#### **GROSS LAND COVERAGE CALCULATIONS WORKSHEET**

# FLOOR AREA CALCULATIONS WORKSHEET

Re: 21 Nethermont Ave - Section, Block & Lot: 122.16/4/41 – Response to RPRC Determination Letter

SHEET 1 of 6

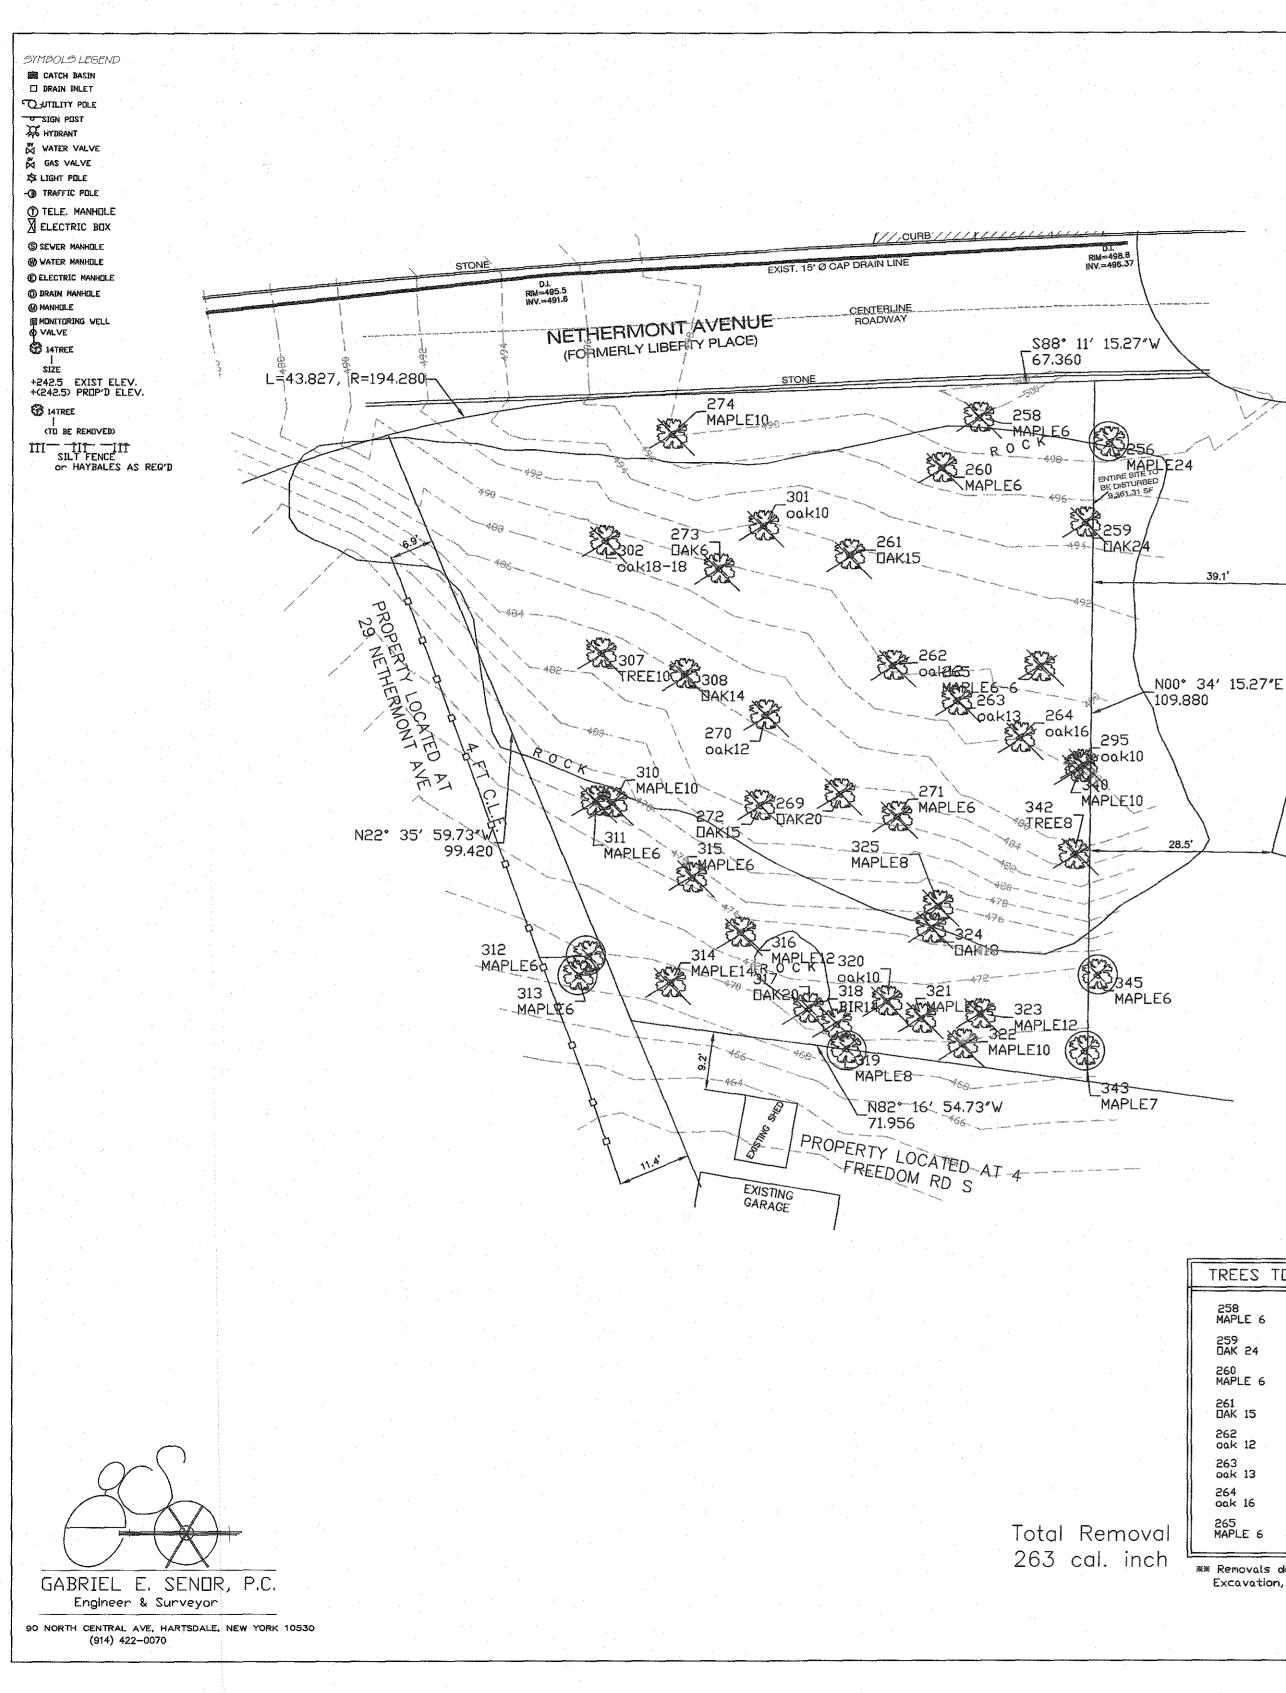
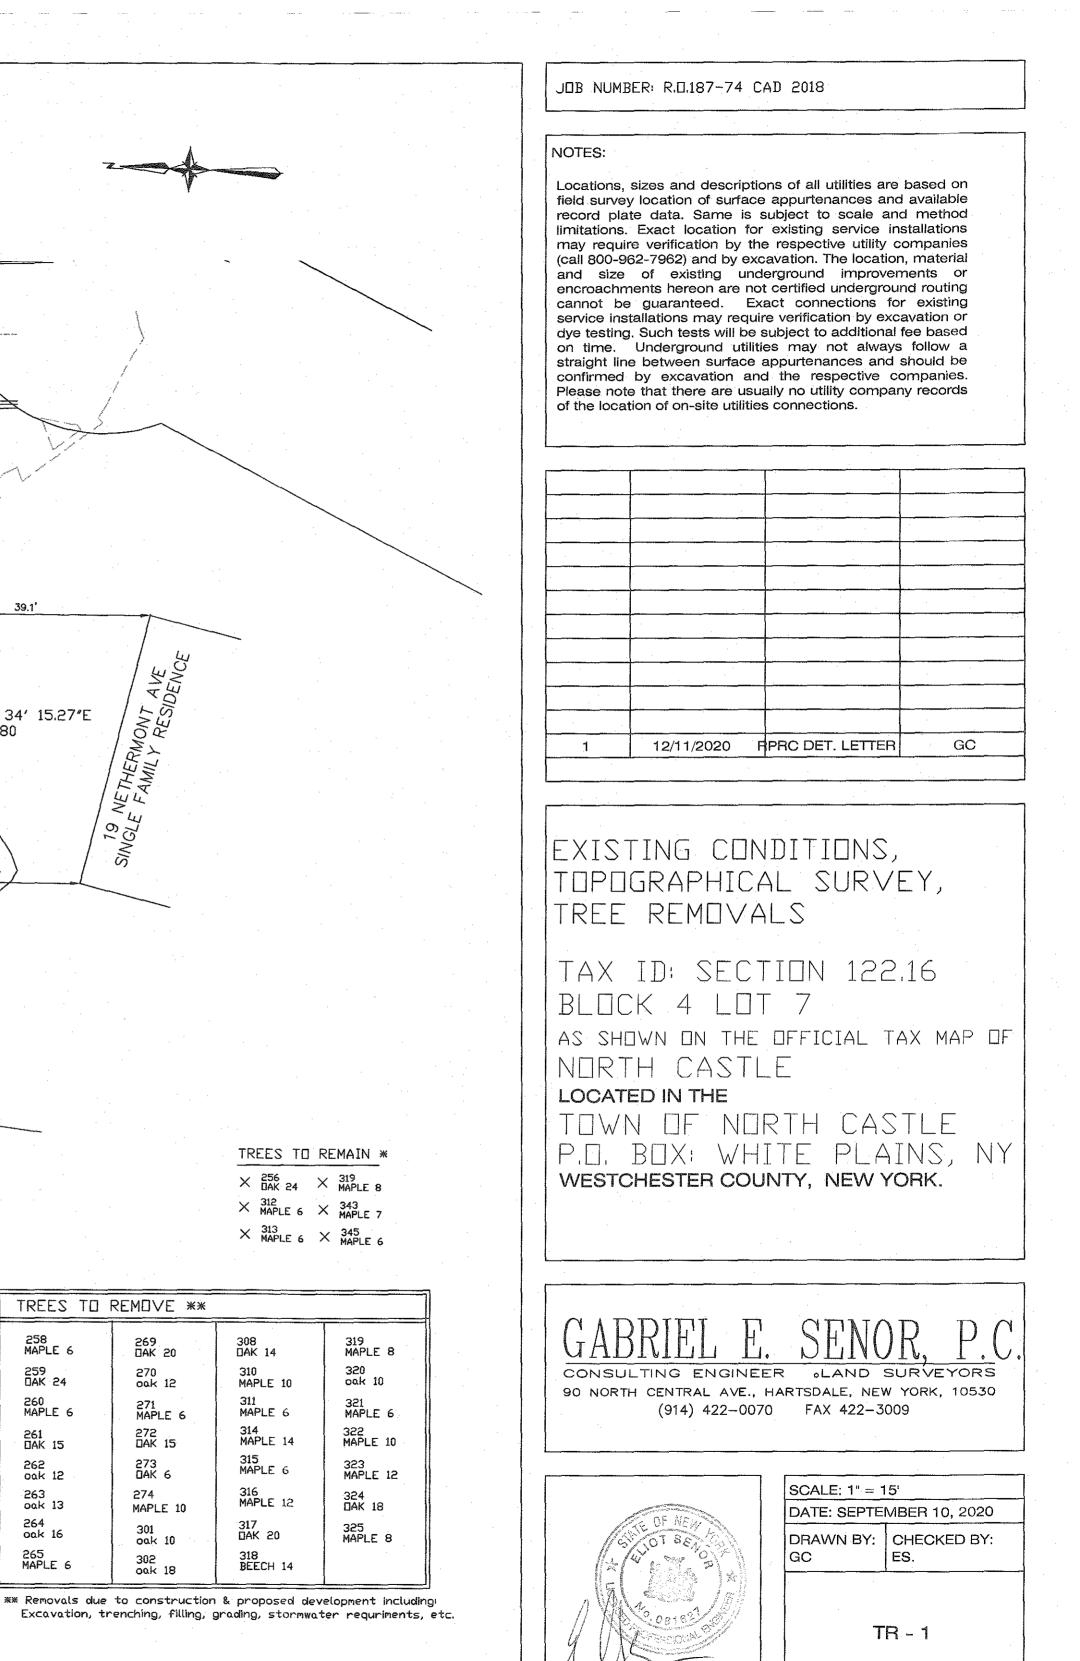
- See GABRIEL E SENOR P.C. Site Plan Package Existing Conditions, Topographical Survey, Tree Removals Plan Sheet 1 of 6, TR-1.
- Pursuant to Section 308-15.A(11) of the Town Code, the Applicant should prepare a plan detailing the replacement proposed to mitigate impacts from the proposed tree removal.

SCALE: 1" = 15' DATE: SEPTEMBER 10, 2020 DRAWN BY: CHECKED BY: ES. TS - 1 SHEET 2 of 6

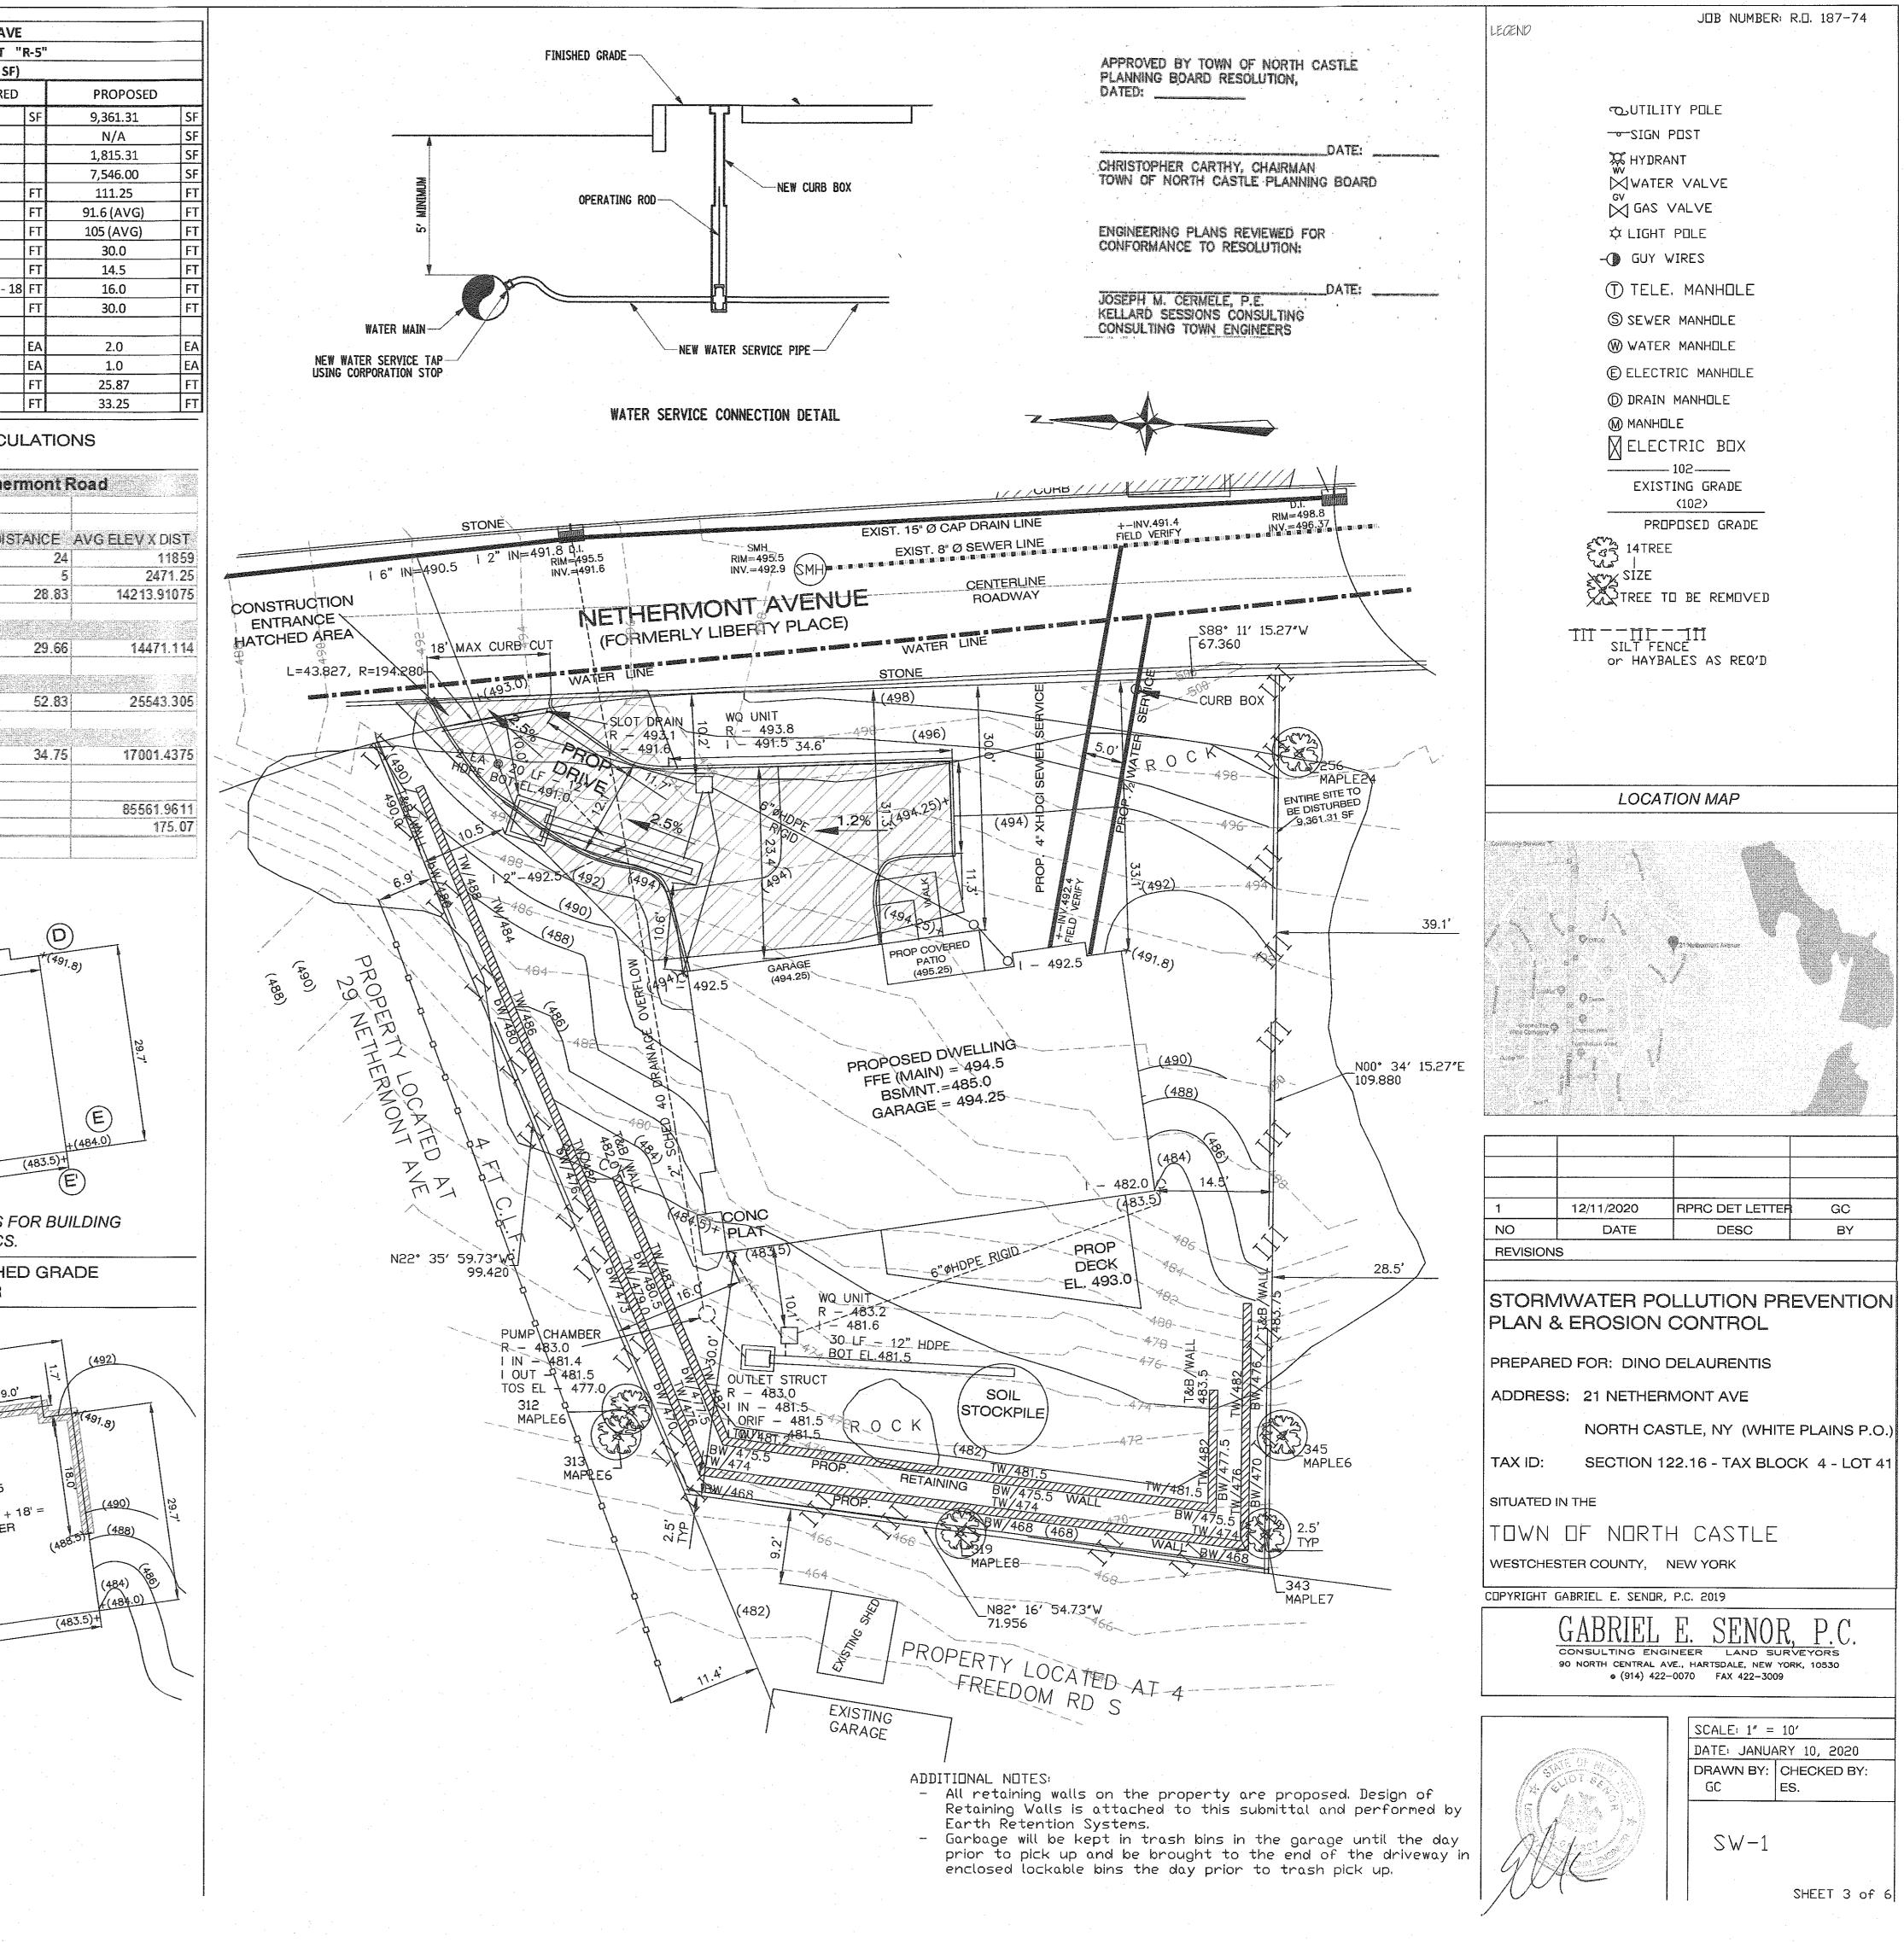
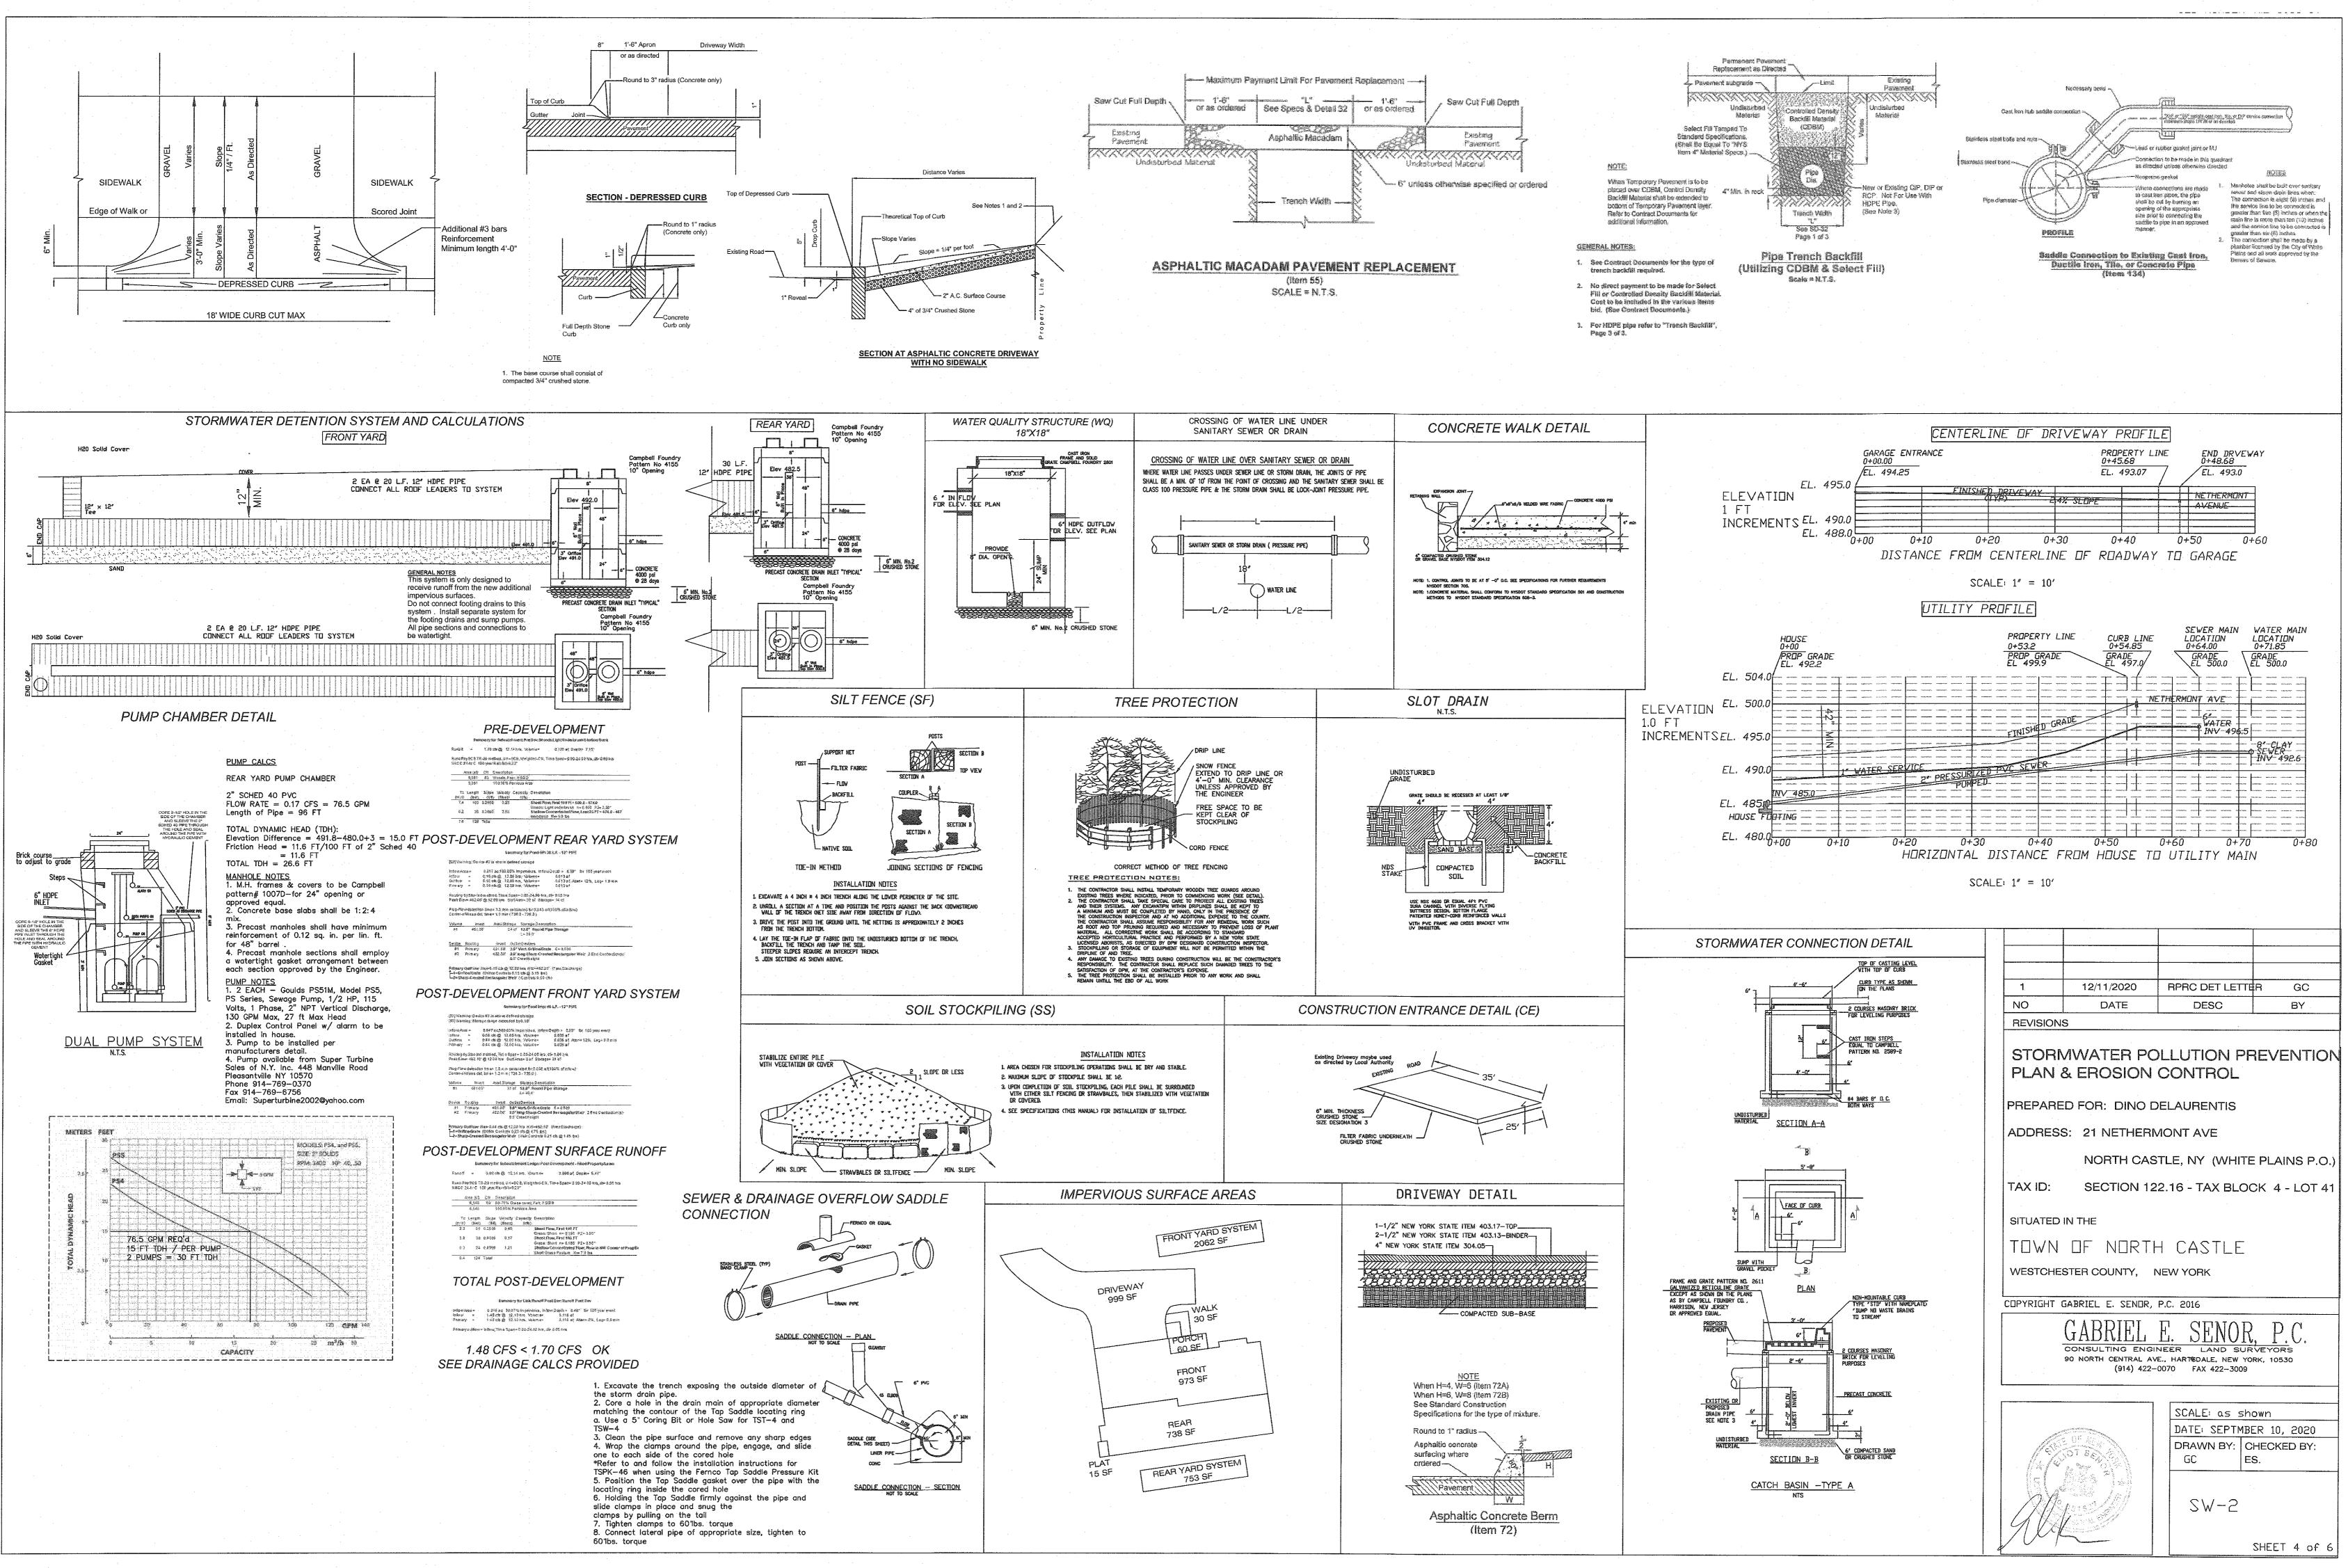
- See GABRIEL E SENOR P.C. Site Plan Package Steep Slope Analysis sheet 2 of 6, TS-1 where all steep slope areas and disturbance within the steep slope areas are clearly shown.
